Determination 2013/066

Regarding the refusal to issue a code compliance certificate due to concerns about compliance of weatherboard fixings to a house at 38 Ostend Road, Waiheke Island

- 2.4.3 As shown in Figure 1 (over page):
- Sketch (A): the Acceptable Solution E2/AS1 calls for rosehead grooved nails that miss the lower board and penetrate into framing by a minimum of 30mm.

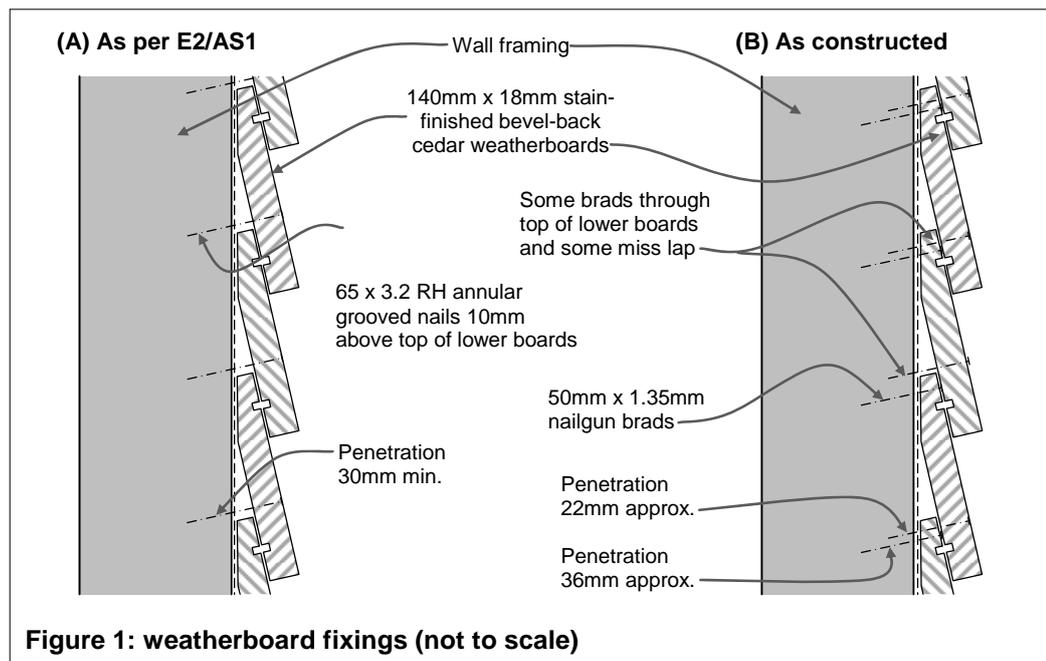
- 2.4.2 The architect’s as-built sketch submitted to the authority (see paragraph 3.4) indicated two adjacent ‘60mm stainless steel senco pins’, with both penetrating the framing by 40mm. However, the expert’s investigations show that the installed weatherboard fixings are as indicated in the sketch in Figure 1(B).

- Sketch (B): the installed fixings consist of 50mm nail gun brads to the top and bottom of each board, with nails to the top of each board penetrating the framing by about 36mm and the bottom nails penetrating into the framing by about 22mm. Some of the bottom nails penetrate through the top of lower boards while some miss the lap, meaning that each board has 2 or 3 nails.

- nails are 50mm x 1.35mm stainless steel nail gun brads, with a small head and a smooth shank without grooves
- the board is nailed top and bottom, with the bottom nail to the left penetrating through the lap of the board below.

- the nail supplier's opinion was that nail gun 50mm brads are generally used as finishing nails as the heads and penetration are too small for fixing boards
- external weatherboards need to resist thermal and moisture effects that can lead to cupping and warping of the boards
- smaller smooth nails small heads are likely to provide insufficient resistance to movement and double nailing boards increases the risk of boards splitting
- the architect's detail does not provide evidence of successful use of this nailing system as the sketch differs significantly from the as-built fixings.

- additional support to the ends of the weatherboards at the crank in the wall, in a similar manner to that provided by the scribes at the doors

- a detailed proposal accurately showing the actual weatherboard fixings and the proposed additional support to the ends of the boards at the crank in the wall.
